STRAWBERRY PARK RESIDENCE
STEAMBOAT SPRINGS
COLORADO

PLAN REVIEW COMMENTS

Job Address: tbd
Applicant: PF Wall, LLC.

Plan Log No. CB-06-438
Designer: CCA

PROJECT NUMBER: 0724

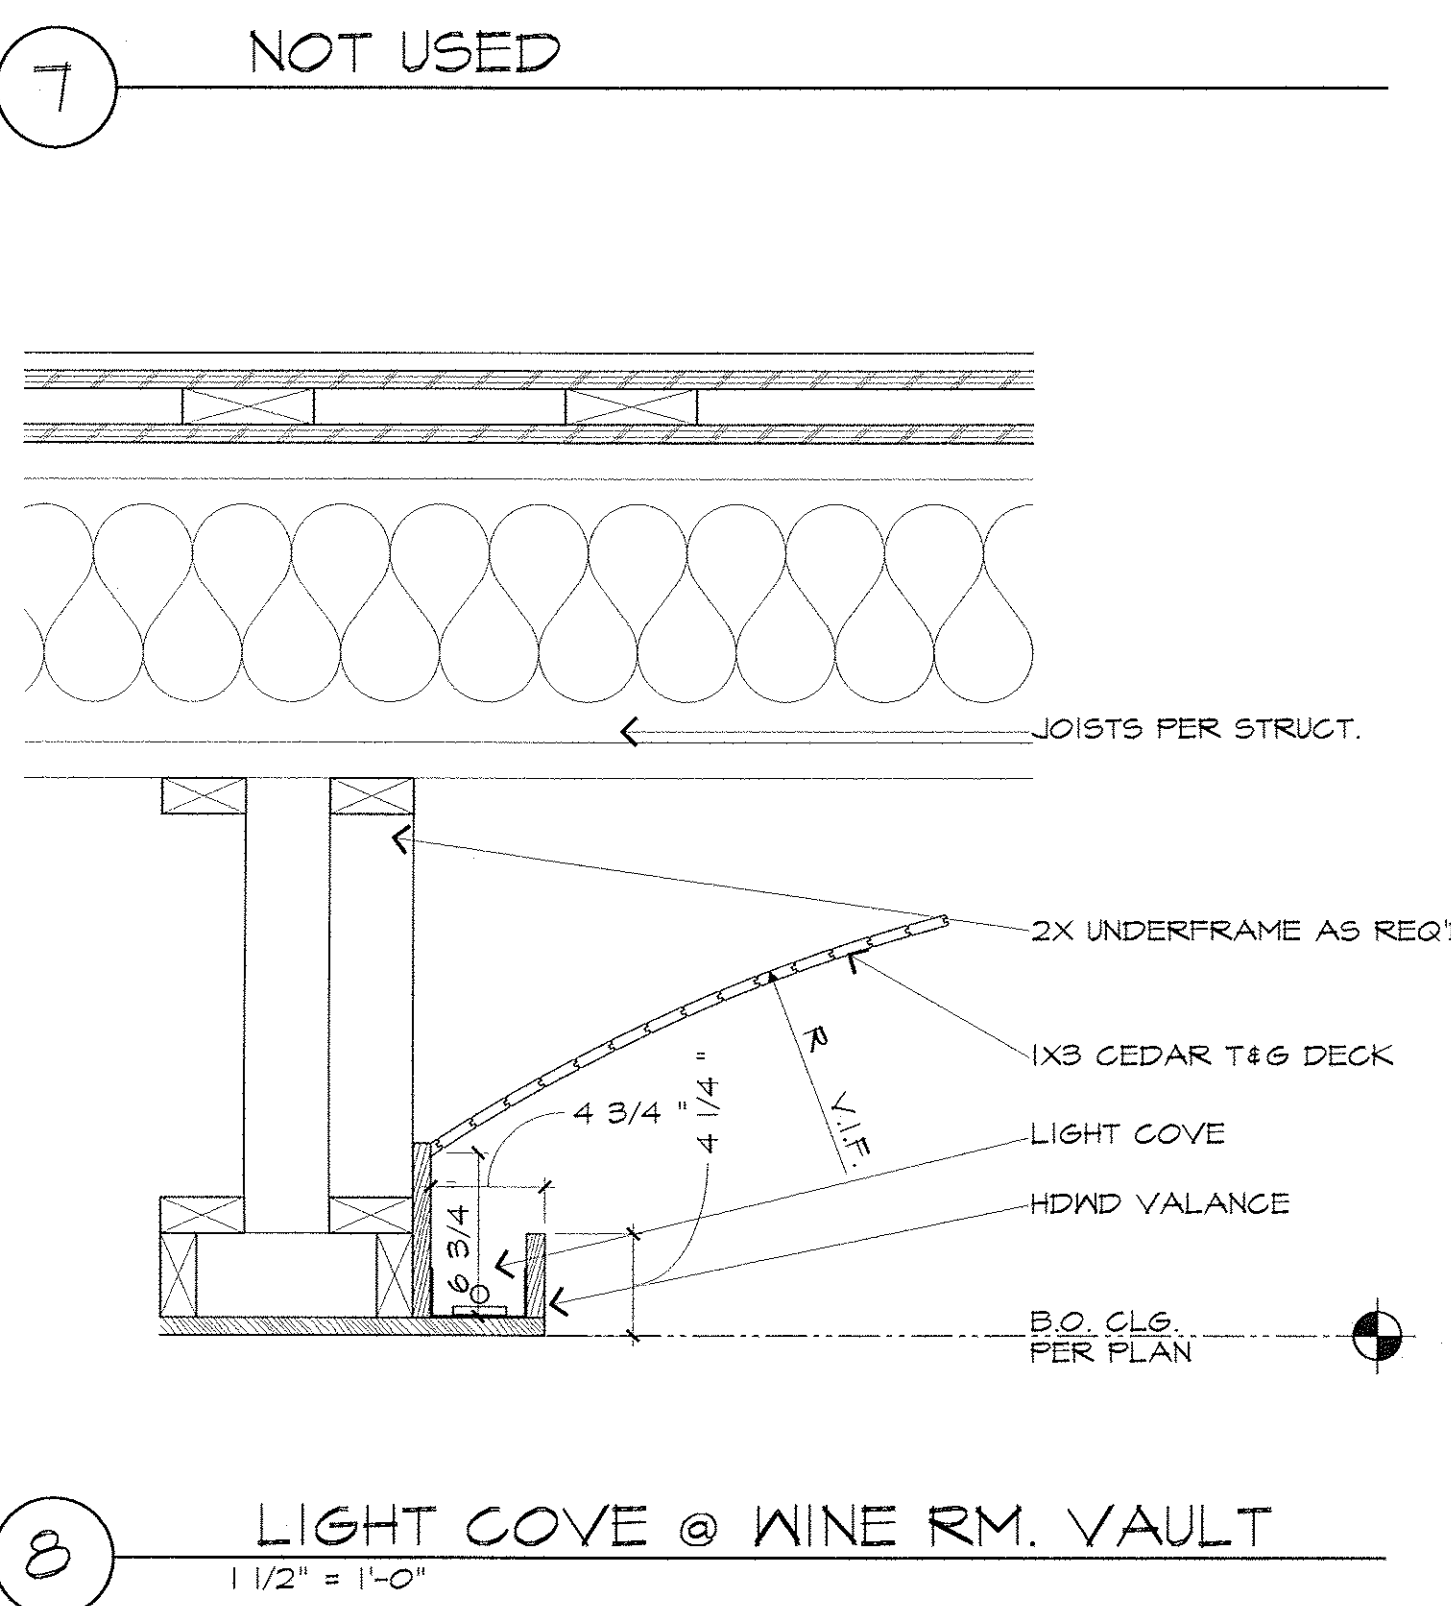
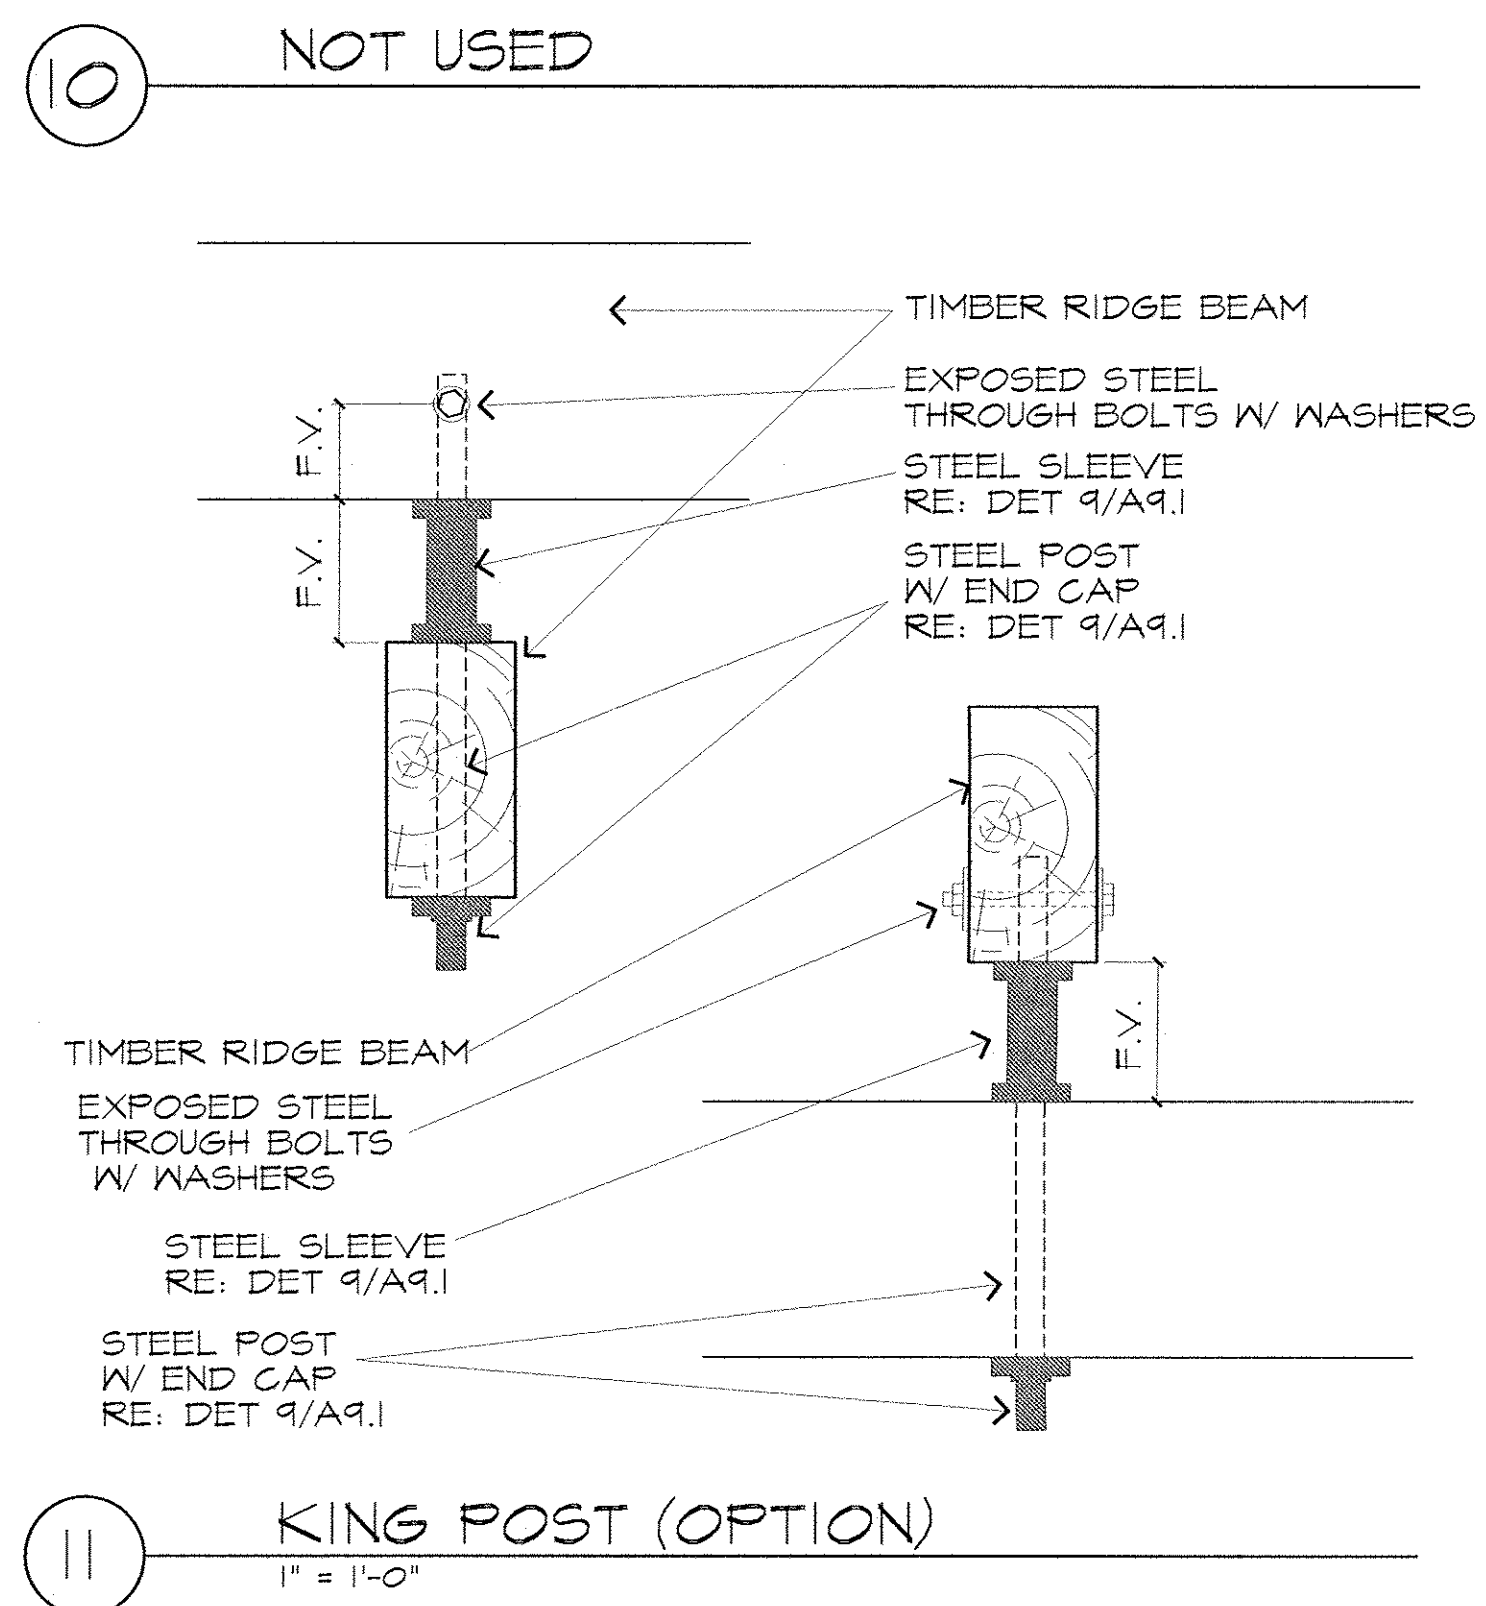
4. Provide a complete concrete fireplace design. See R1003. Show how you will comply with R1003.9, .10, .11, R1005.
5. Show how you will comply with "cablerail specifications". 5 & 12/A9.2 and 5 & 12/A9.3. Guardrails from aircraft cables Documentation from a manufacturer of cable guardrail explains that the cables must be installed at a spacing closer than that required by the UBC. The published installation instructions from this manufacturer show a maximum post spacing of 4.5 feet with a vertical spacer midway between the posts to hold the cables in line and prevent deflection of the wire. The maximum spacing of the cable is 3 inches o/c.

1. Foundation Only has been removed from the full set of structural drawings issued for full permit.
2. A retaining wall design for walls up to 10 feet has been provided.
3. A note has been added to the plans stating that the media room will receive light and ventilation per code minimums via artificial light and a HRV.
4. The fireplace specified is 5 piece modular conc. unit manufactured by Contempo Fireplaces, Alb, NM—A cut sheet, install manual and manufacturer details are contained in this document. (attached)
5. Manufacturer specs have been attached for the cable rails and details in plan set now reference this Manufacturer.
6. See item 4.
7. Complete structural drawings have been provided.
